AX PRO

Version: V1.2.0

Release Note

(2020-07-27)

2) Add SMS Remote Control Function:

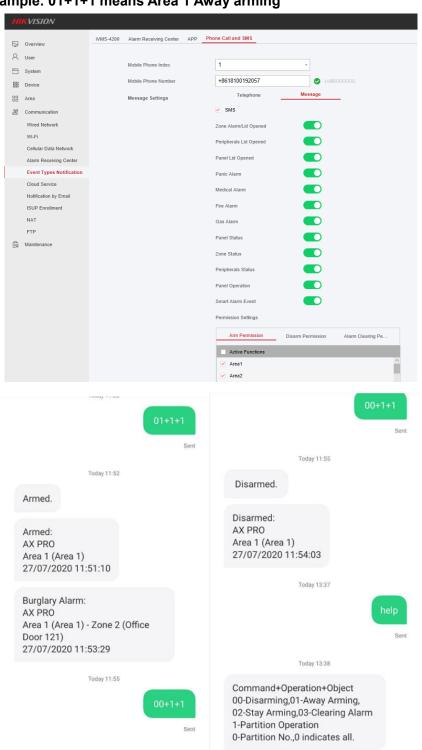
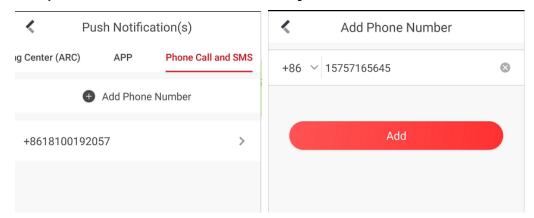
SMS remote control command:

"Command + Operate type + Operate Object"

Command: 00—Disarm, 01—Away arming, 02—Stay arming, 03—Clear alarm

Operate type: 1—Area operate

Operate Object: 0—All Area, 1—Area 1, 2—Area 2, 3—Area 3, 4—Area 4 and so

Example: 01+1+1 means Area 1 Away arming

4) Add Stay Arm Delay Time Configuration

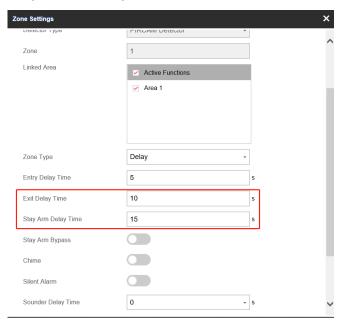
Customer can configure different Exit Delay Time for Stay arm and Away arm.

For Example: Away Arm Exit delay time is 10s

Stay Arm Exit delay time is 15s

5) Add Key Switch zone trigger type.

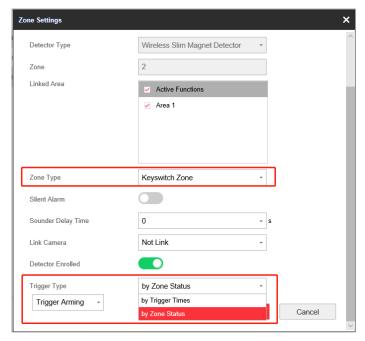
Add the key zone trigger type---By Trigger Time

By trigger Times: First time triggered will arm the Partition, second time triggered will disarm the partition.

By Zone Status: The linked area will arm after being triggered, and disarm after being restored.

6) SIA DC09 protocol Function Optimization

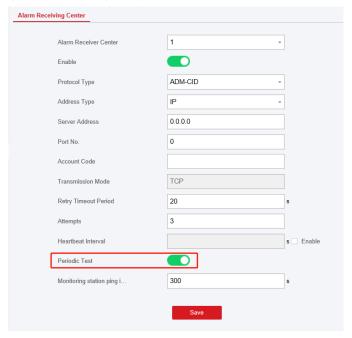
Periodic Test function: After the Periodic Test function is enabled and configured, the alarm receiving center can regularly receive the reported test events.

7) Support add Thermal camera to get smart Alarm notification

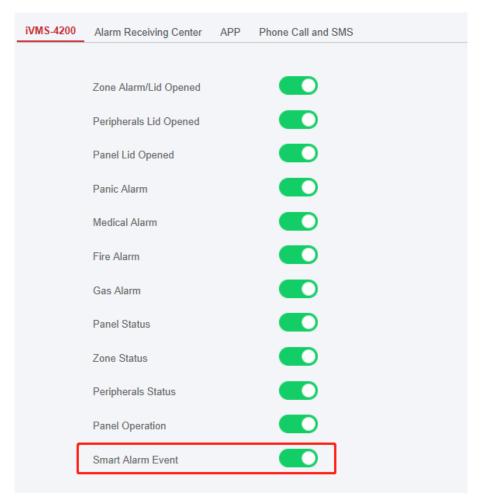
After add the Thermal camera to Panel, Panel can get the notification form camera and send it to the 4200/Alarm receiver Center/Hik-Connect/SMS.

Smart Alarm Event: entering area alarm, leaving area alarm, cross-line alarm, intrusion alarm, low temperature warning, low temperature alarm, high temperature warning, high temperature alarm, fire point detection.

Support models: DS-2TD1117 Series, DS-2TD1217 Series, DS-2TD2617 Series, DS-2TD2117 Series

8) Add Bypass On Re-Arm Function

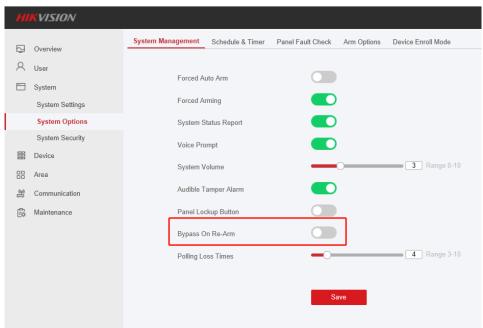
Bypass On Re-Arm: When you Forced Arming the Panel, the Fault zone will be bypassed, and if the zone fault recovered during arm time, the zone will be back to arm mode automatically.

9) Add Instant Zone Forbid Bypass on Arming Function

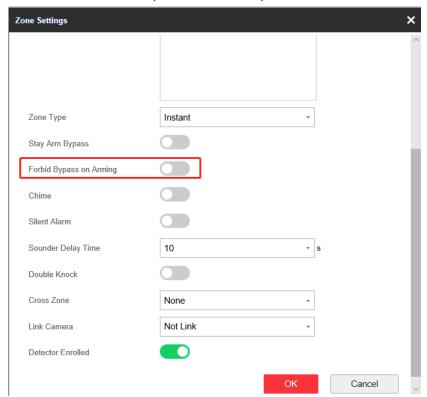
Forbid Bypass on Arming: If enabled, the instant zone will not be able to force arming when zone on fault status. (Default disabled.)

10) Add Sounder Delay Time Function

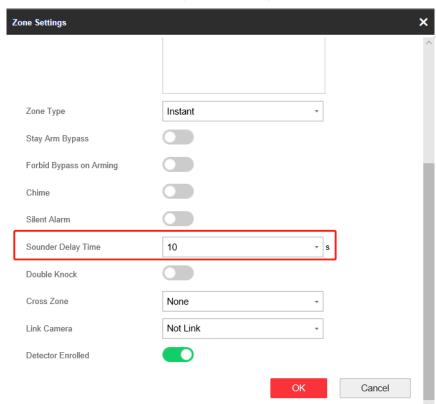
Sounder Delay Time: When zone triggered, the sounder delay alarm time. Default 0s, you can configure the time from 0~120s.

12) Add APP Detector Find Me Function

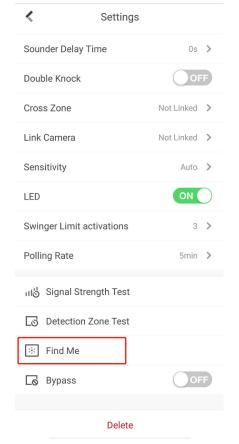
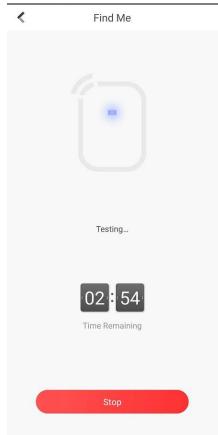
When you Select Detector configuration interface and enable it, the detector Light will flash to show detector location.

APP Hik-connect need Android v4.6.1.0721 and IOS v1.2.1.3

13) Support add Camera from NVR channel:

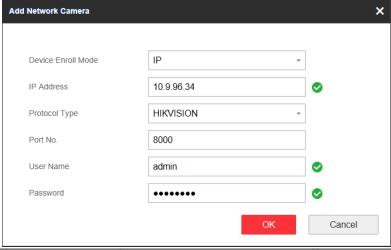
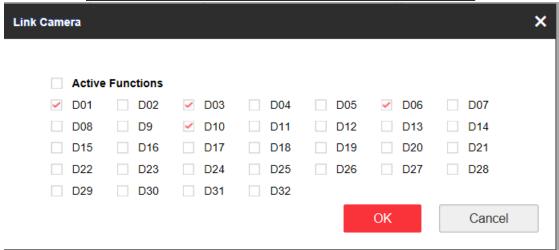
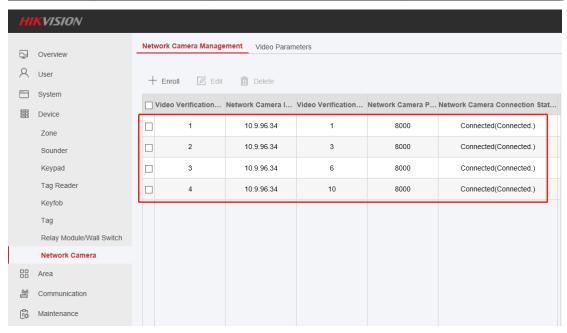
Then Panel 7S Video Verification support add camera from NVR channel, customer can select NVR channel (Including POE channel).

1) Login Logic Optimization

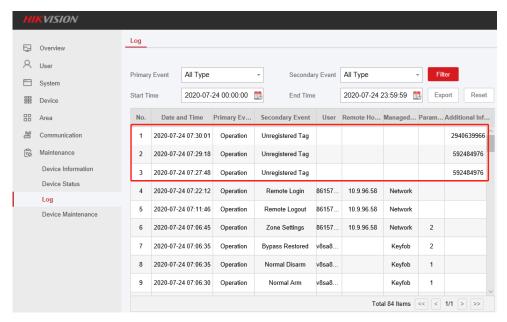
When admin account and installer account use same account (Email or Phone number) and password to login, permission defaults use installer permissions.
